**AMENDMENTS TO THE DRAWINGS**

**REMARKS/ARGUMENT****I. Disposition of Claims**

FIGURE 2

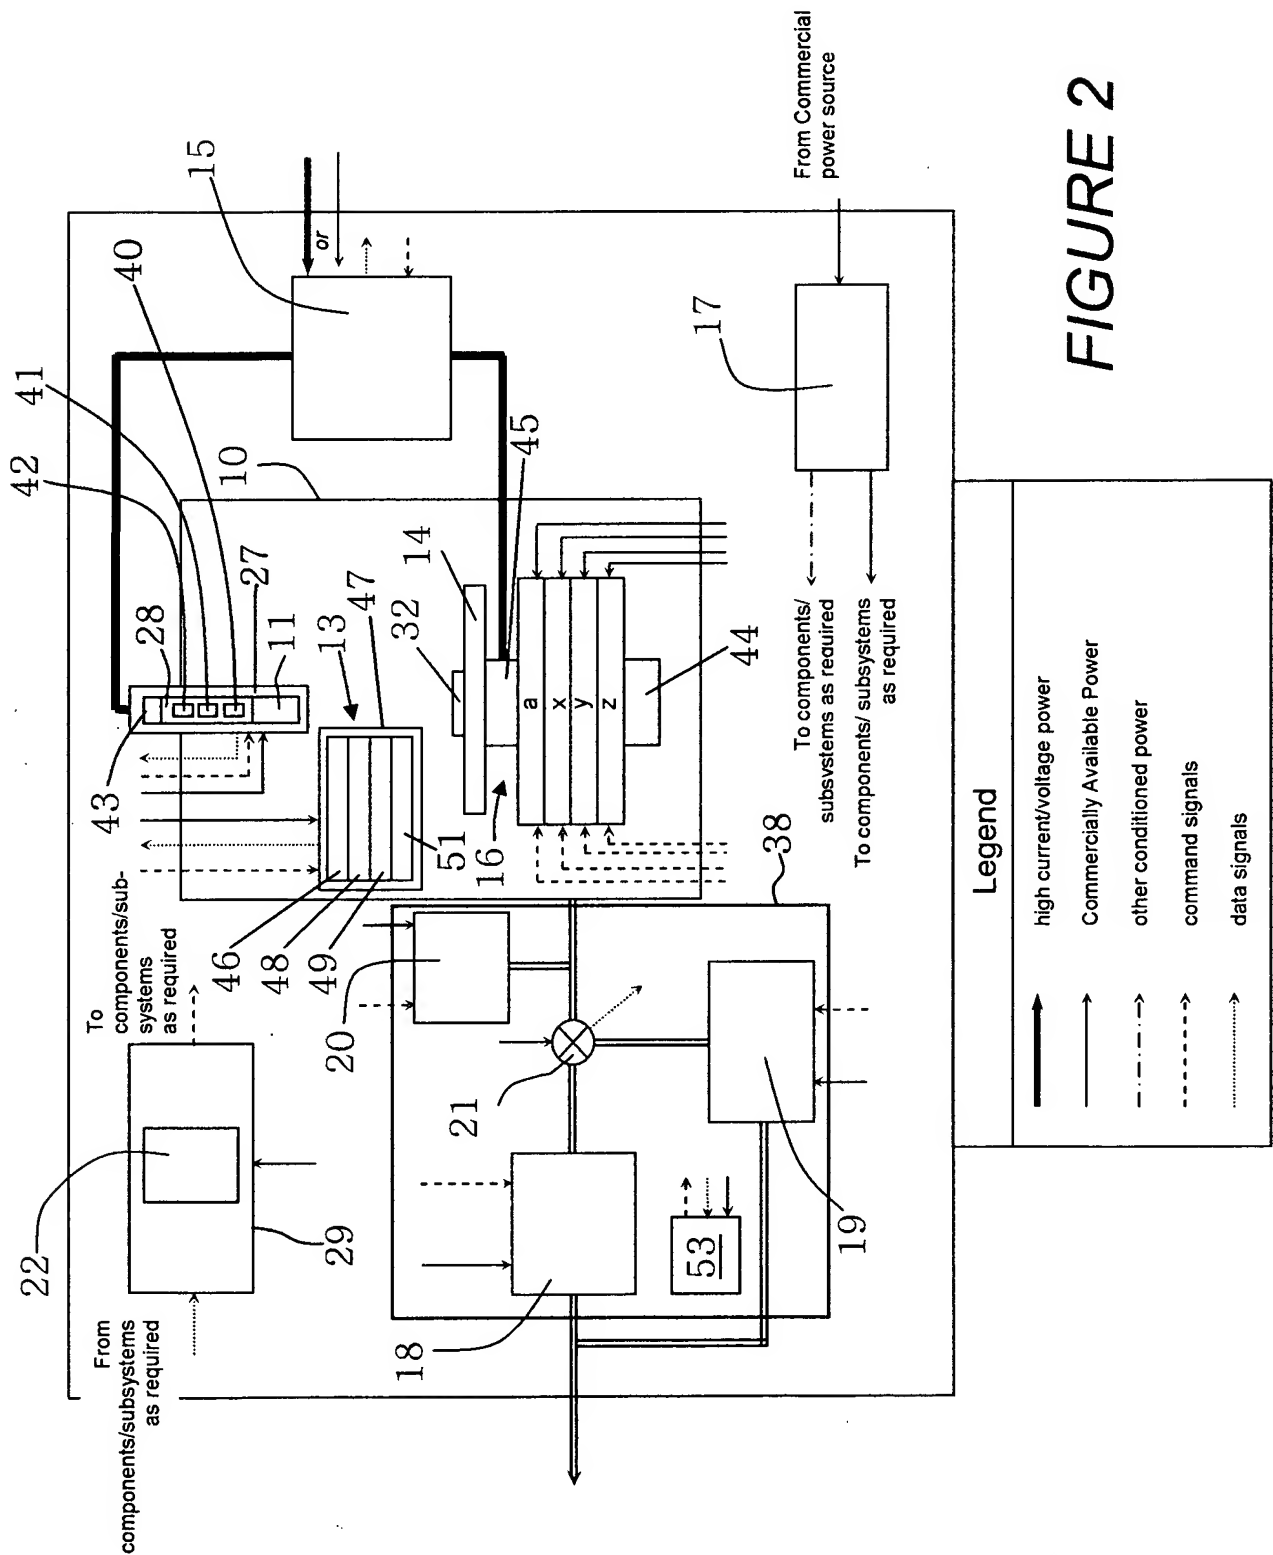
The attached sheets include changes to FIG. 2. These sheets, which includes a replacement sheet and annotated sheet of FIG. 2, replace the original sheet including FIG. 2. In FIG. 2, the following previously omitted elements have been included. All added elements to FIG. 2 are supported by the Applicants' specification, claims, or both as originally filed.

<u>Element No.</u>	<u>Element Name</u>	<u>Reference in Spec/Claim</u>
27	Electron Beam Subsystem	Paragraph [0023]
28	Electron Beam Control Element	Paragraph [0023]
29	Instrumentation Subsystem	Paragraph [0023]
38	Vacuum Subsystem	Paragraph [0025]
39	Reserved	
40	Auxiliary Vacuum Pump	Paragraph [0023]
41	Service Panel	Paragraph [0023]
42	User Interface Screen	Paragraph [0023]
43	Electron Beam Positioning Subsystem	Claim 22
44	Positioning Subsystem Control Element	Paragraph [0029]
45	Positioning Subsystem Motor	Paragraph [0029]
46	Wire Feedstock (Supply)	Paragraph [0033]
47	Wire Feed Housing	Claim 37
48	Wire Feed Motor	Paragraph [0033]
49	Wire Feeding Mechanism	Paragraph [0033]
50	Reserved	
51	Wire Feed Control Element	Paragraph [0033]
52	Reserved	
53	Vacuum Control Element	Paragraph [0025]

FIG. 2 has been amended to comply with 37 CFR 1.83(a) (ref: MPEP 608:02(d)). Additions have been limited to labeled box representations and hence, no new matter has been added. All elements added in FIG. 2 were disclosed in the Applicants' specification, claims, or both as originally filed. The USPTO's acceptance of the drawing amendment is earnestly solicited.
